FIELD SAFETY NOTICE

HEMAPATCH WOVEN

Affected Product(s): HEMAPATCH Woven

Figure 2: HEMAPATCH Woven surfaces

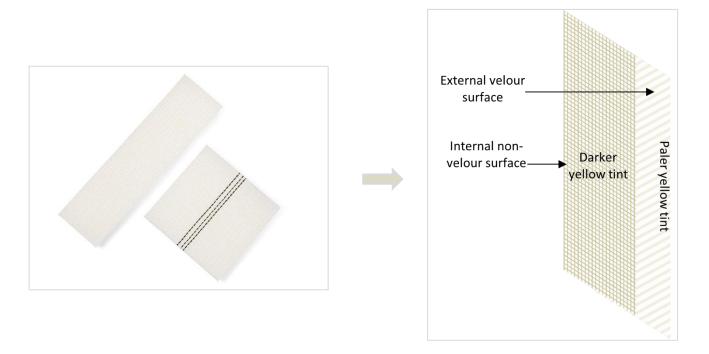
- The DFU above is specific to HEMAPATCH/HEMAGARD PATCH Knitted and is not applicable for HEMAPATCH Woven.
- The DFU for HEMAPATCH Woven is provided in the section related to the action taken by Intervascular/Getinge (page 4).

o For **HEMAPATCH Woven**, the direction for use below should be followed:

"The **external velour surface**, which has a **paler yellow tint**, should face outward, away from the blood flow. The **darker yellow inner non-velour surface** should face inward, in contact with the blood flow."
